Our Case Number: ABP-317874-23

Re: Extraction of sand and gravel from quarry. An Environmental Impact Assessment Report (EIAR) and a Natura Impact Statement (NIS) have been submitted
Walterstown, Hollywood, Co. Wicklow

Re: APPEAL | ABP-317874-23 | Extraction of sand and gravel materials from the site. The proposed site area is 8.44 hectares, and the proposed extraction area is 5.52 hectares. The proposed development includes a surface mounted weighbridge, wheel wash, porta cabin office, canteen and welfare facilities with all site ancillary works, and fencing. It is proposed to extract 50,000 tonnes per annum for a period of 10 years. An Environmental Impact Assessment Report (EIAR) and a Nutura Impact Statement (NIS) have been submitted in respect of the proposed development at Walterstown, Hollywood, Co. Wicklow.

To: Siobhan O'Brien Senior Executive Officer Planning & Economic Development	From: Michael Boland Executive Scientist Waste Management Section
Date: 17th December 2021	
Subject: Dempsey Sand & Gravel – New S&G pit in Walterstown Application No. 21/1372

DRAWING TITLE: Proposed Phasing Plan

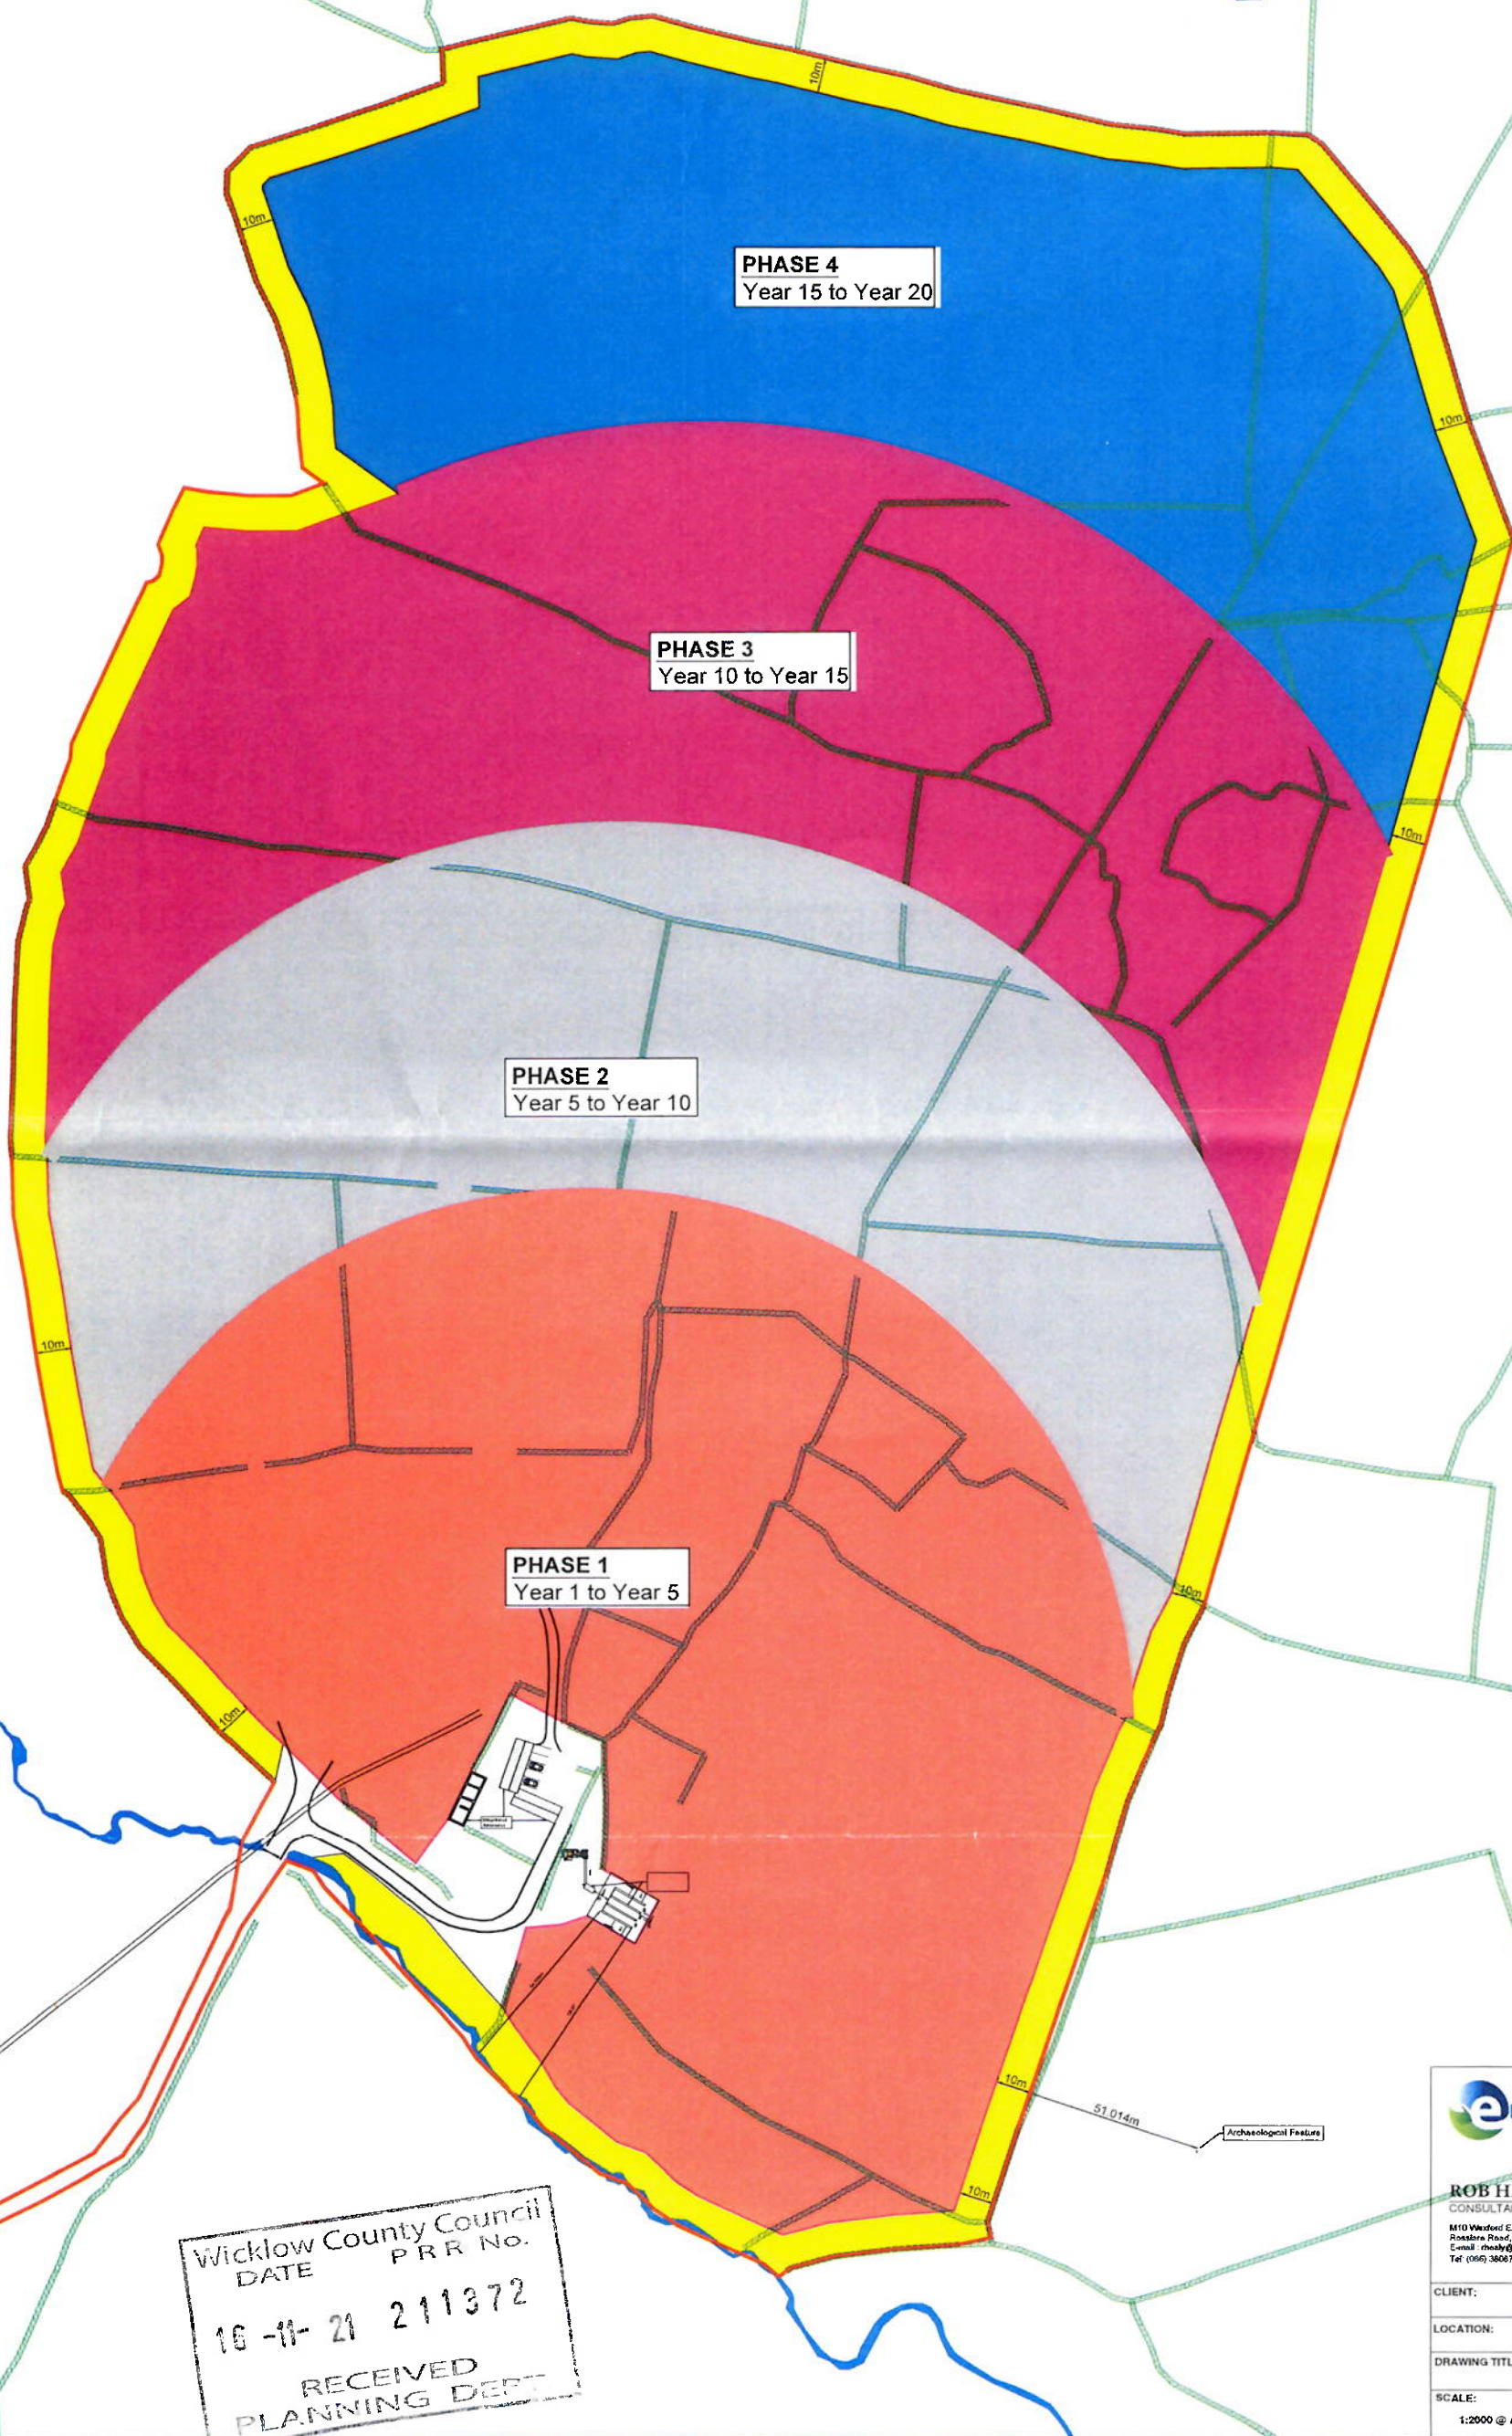
Drawing P-09 "Proposed Phasing Plan" indicates a four Phase Plan spread over 20 years. The EIAR also indicates that it is planned to extract 30,000 tonnes in year 1, 50,000 tonnes in year 2 and 70,000 tonnes year 3 onwards (Page 14, Section 2.4 Project Overview). This would account for 1,340,000 tonnes. This Section also indicates that there are 3,400,000 tonnes of sand which could be processed on-site over the total lifetime of the quarry.

Drawing P-09 "Proposed Phasing Plan" indicates a four Phase Plan spread over 20 years. The EIAR also indicates that it is planned to extract 30,000 tonnes in year 1, 50,000 tonnes in year 2 and 70,000 tonnes year 3 onwards (Page 14, Section 2.4 Project Overview). This would account for 1,340,000 tonnes. This Section also indicates that there are 3,400,000 tonnes of sand which could be processed on-site over the total lifetime of the quarry.
